**ADDENDUM NO. 2****VILLAGE OF ESSEX JUNCTION, VERMONT****CONSTRUCTION OF THE DENSMORE DRIVE CULVERT REPLACEMENT**

This Addendum forms part of the Contract Documents and modifies the original Drawings and Specifications dated October 2020. This Addendum consists of 2 pages of modifications to the contract documents consisting of pages ADDM-1 through ADDM-2.

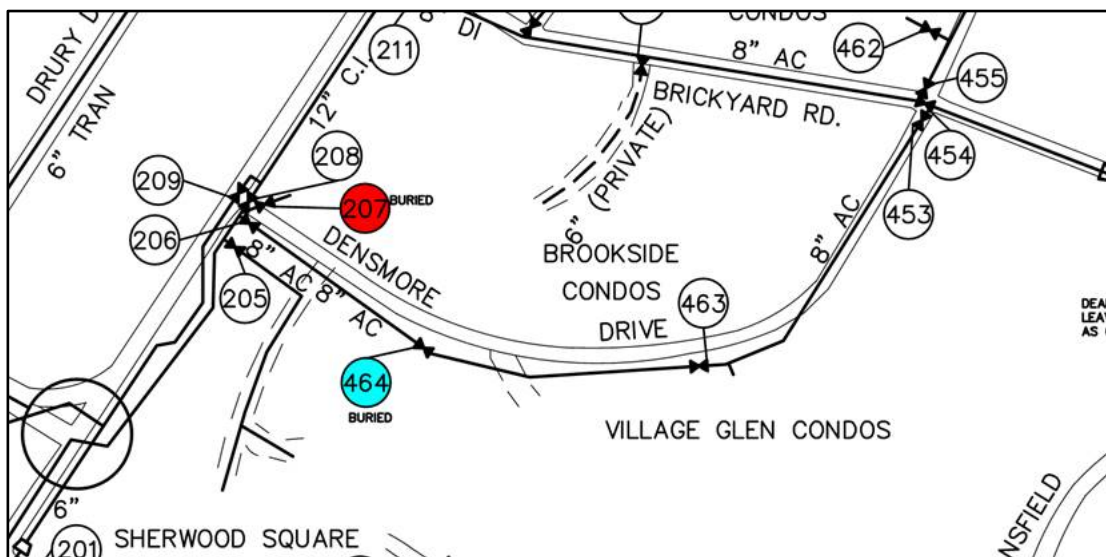
Question 2: How many tie ins and location are there (temporary water)?

***Valves 206 and 464, as shown below, may be temporarily closed to complete the project per the plans and specifications. These valves will be tested, temporarily closed this fall/winter to verify that they are functioning properly and to confirm the abutters do not lose service.***
